ADDENDUM NO. 5

DATE: April 3, 2020

PROJECT: ITB 20343
BETHUNE POINT WATER RECLAMATION FACILITY
GENERATOR REPLACEMENT

A SECTION
S-101 SCALE: 1/2" = 1'-0"

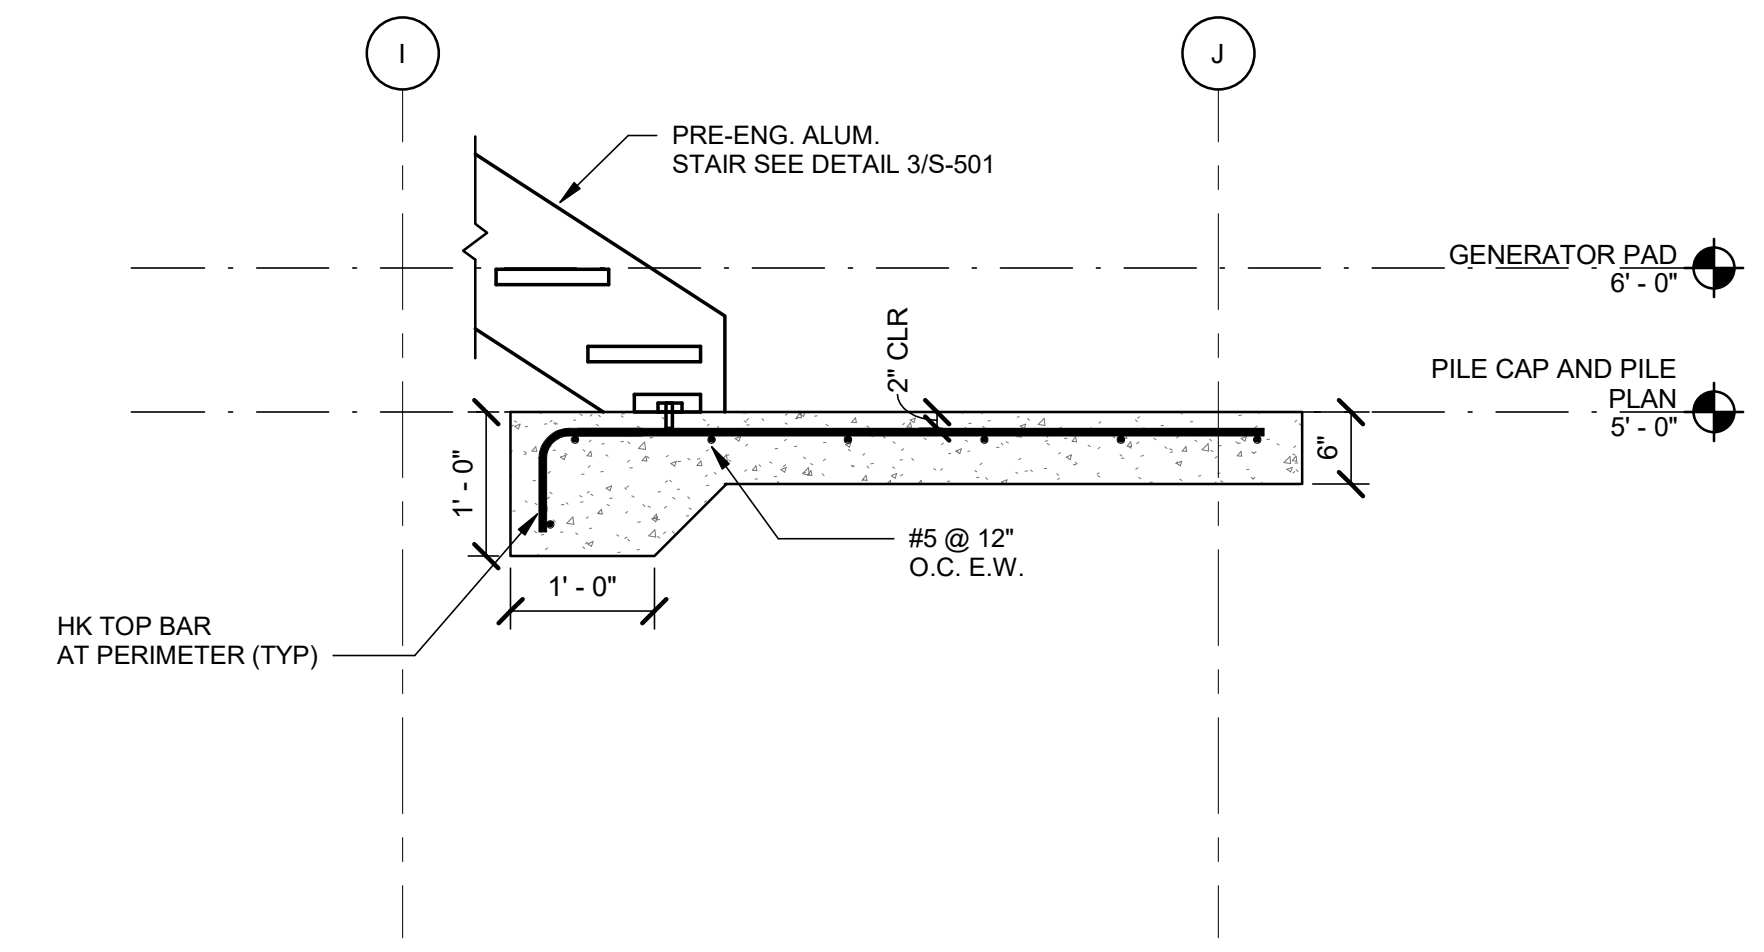
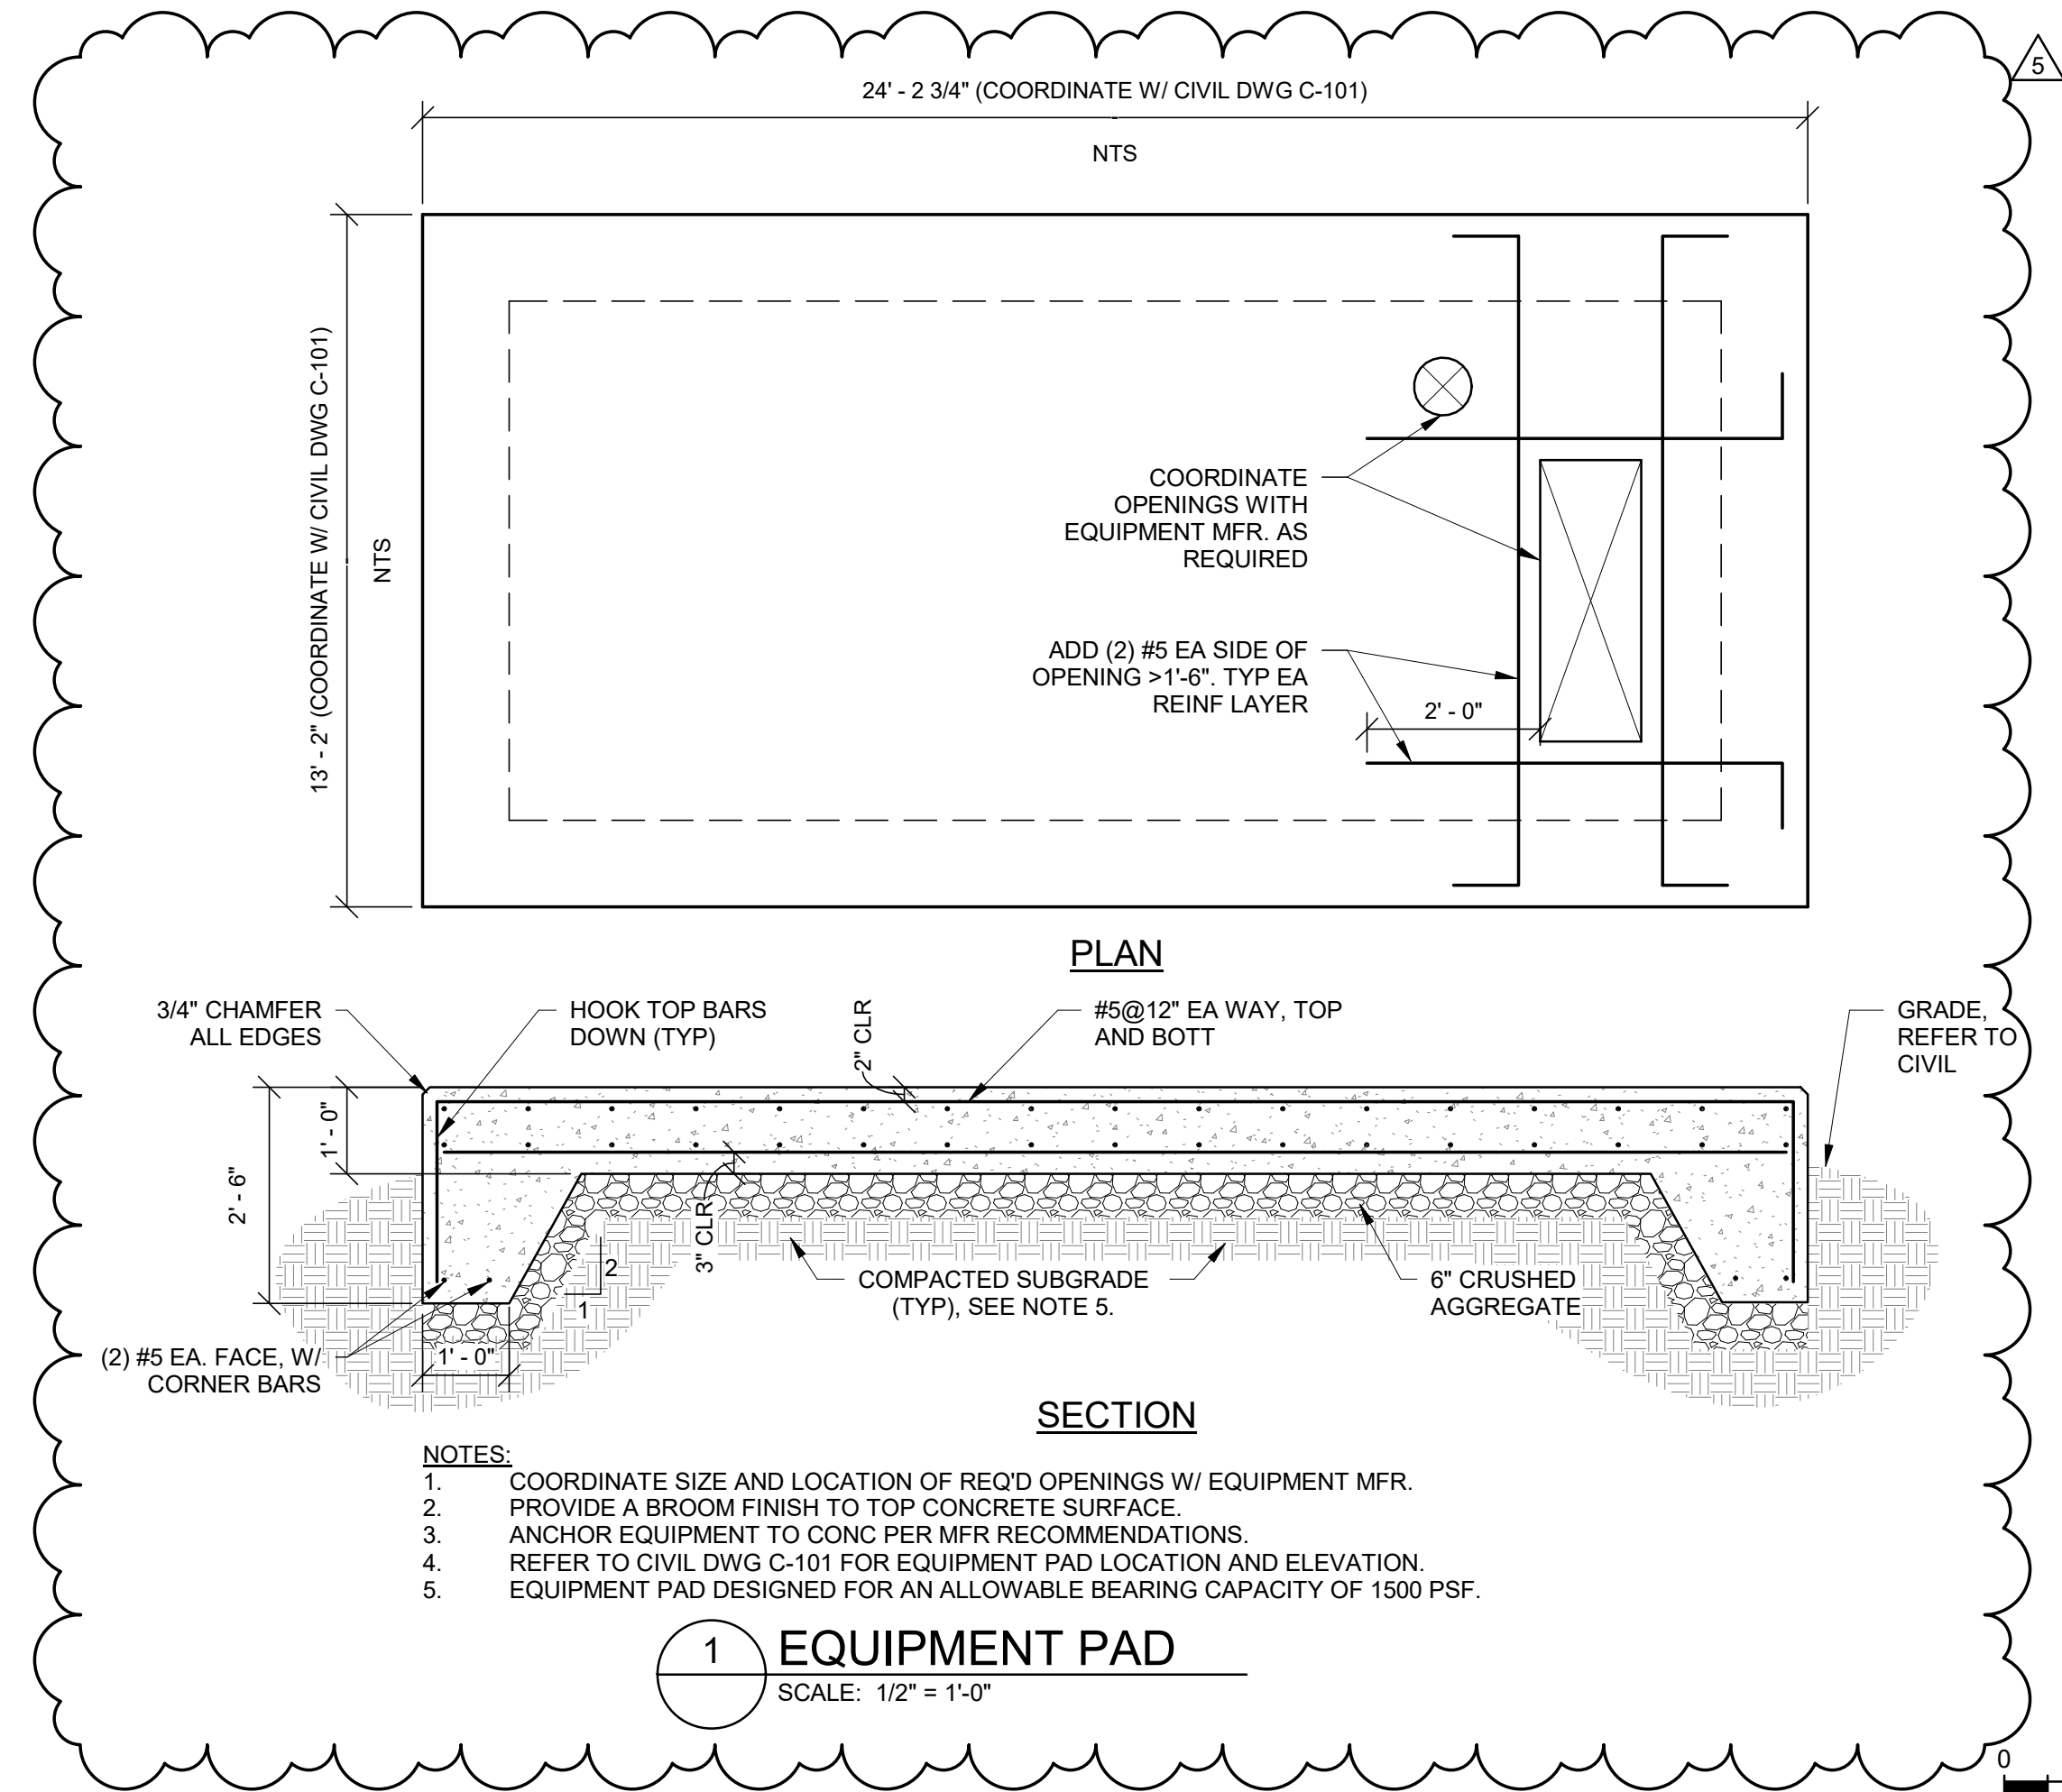
B. Please see revised Sheets S-101 and S-301 attached. Revisions are highlighted by clouds.
